ADDENDUM NUMBER 3
TO THE DRAWINGS AND SPECIFICATIONS

PROJECT: McLean County Unit District No. 5 Chiddix Junior High School HVAC Renovation

A/E PROJECT NO: 23472320

01 HVAC RENOVATION
AREA D - GROUND FLOOR PLAN
SCALE: 1/8"=1'-0"

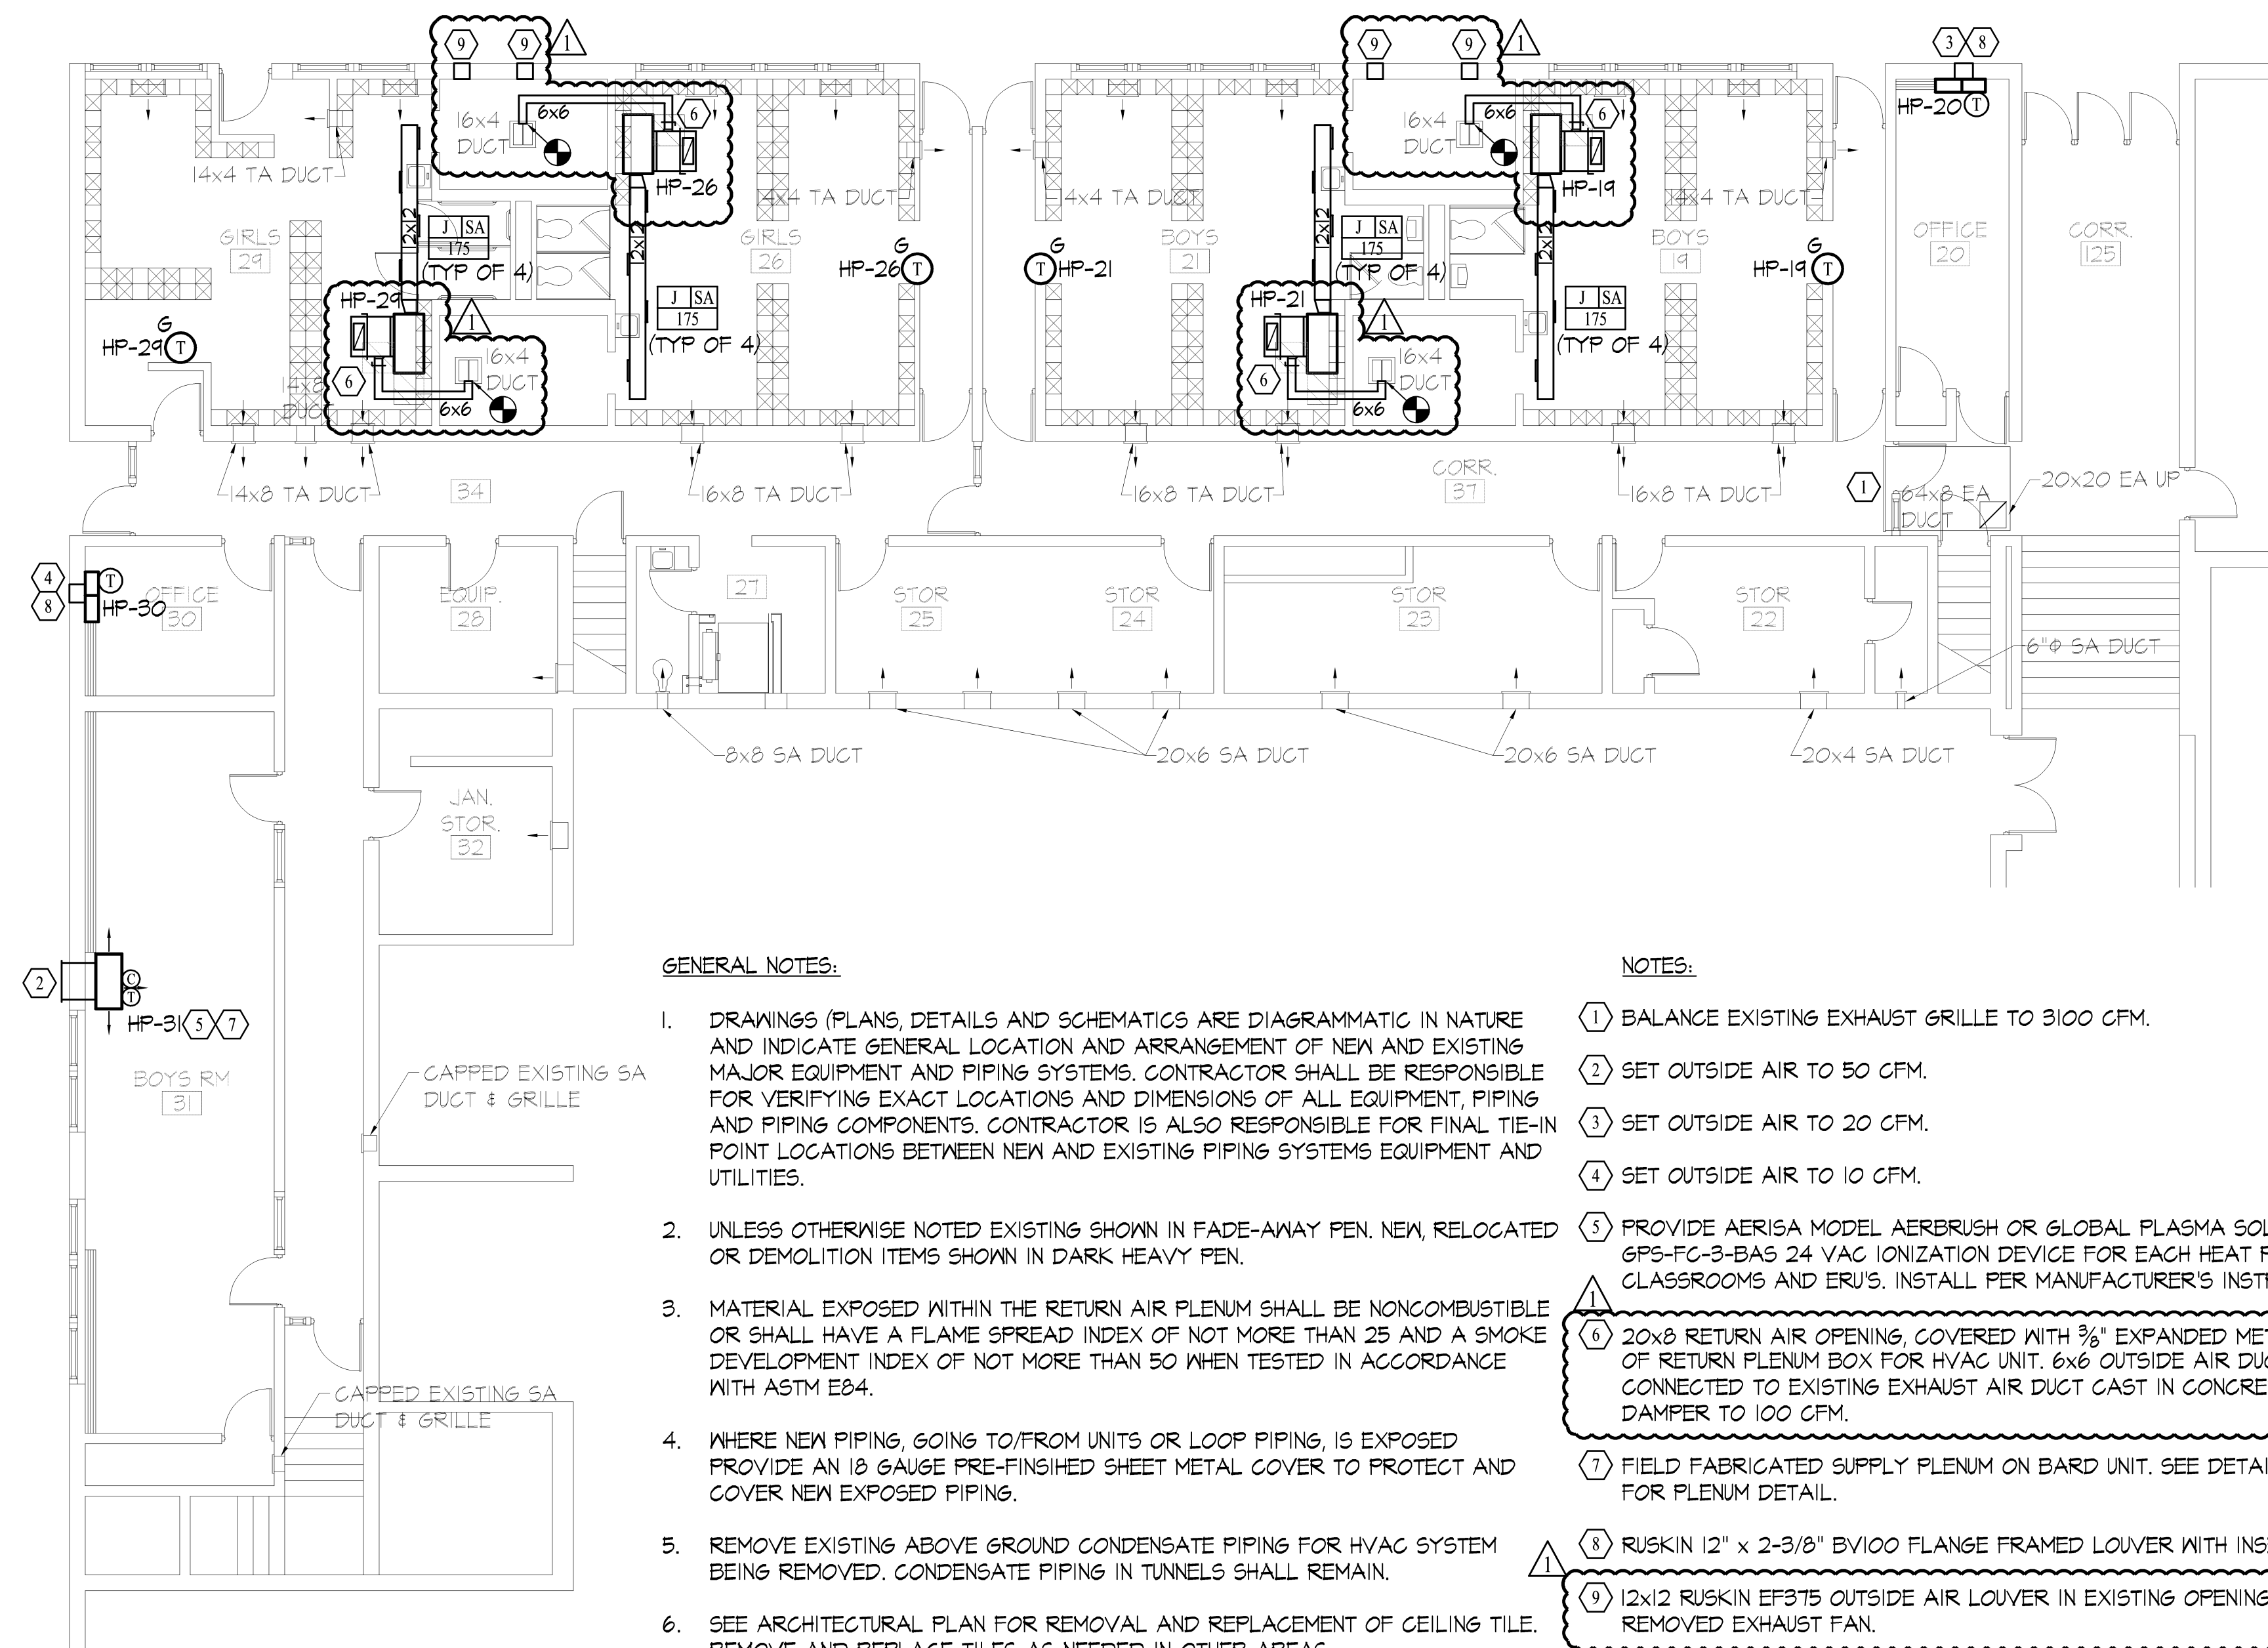
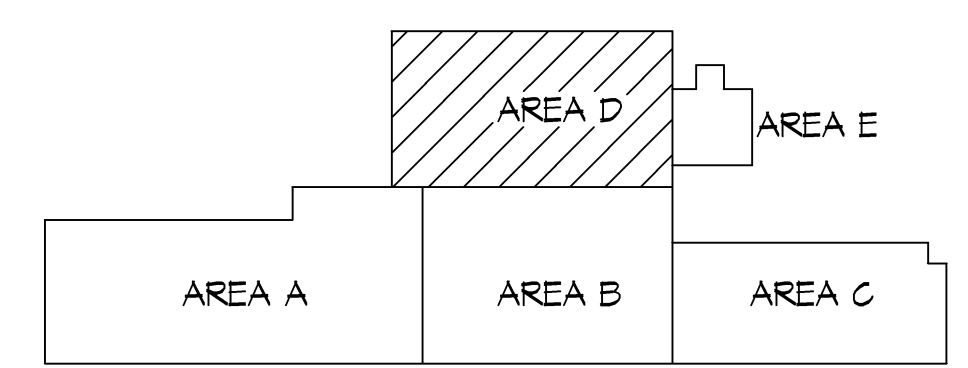
11. TO THE DRAWINGS: Drawing M1.7: The 52"x48" duct indicated on drawing 02 to be removed from the roof shall be removed by the general contractor.
12. TO THE DRAWINGS: Drawing M1.9: Revise the outside air ductwork to the locker room heat pumps per the attached revised drawing M1.9.
13. TO THE DRAWINGS: Drawing M3.1: The antifreeze solution shall be 20% Propylene Glycol. The calculations for the required volume of glycol in the borefield as indicated on drawing M0.2 are correct for 20% glycol solution.
14. TO THE SPECIFICATIONS: Specification Section 23 8127: Carrier is approved as a heat pump equipment supplier. Carrier model 50PEC may be bid in place of Waterfurnace NCS models, Carrier 50HQP may be bid in place of Waterfurnace NLV models, and Carrier PTH/PTV may be bid in place of Waterfurnace NBH/NBV models.
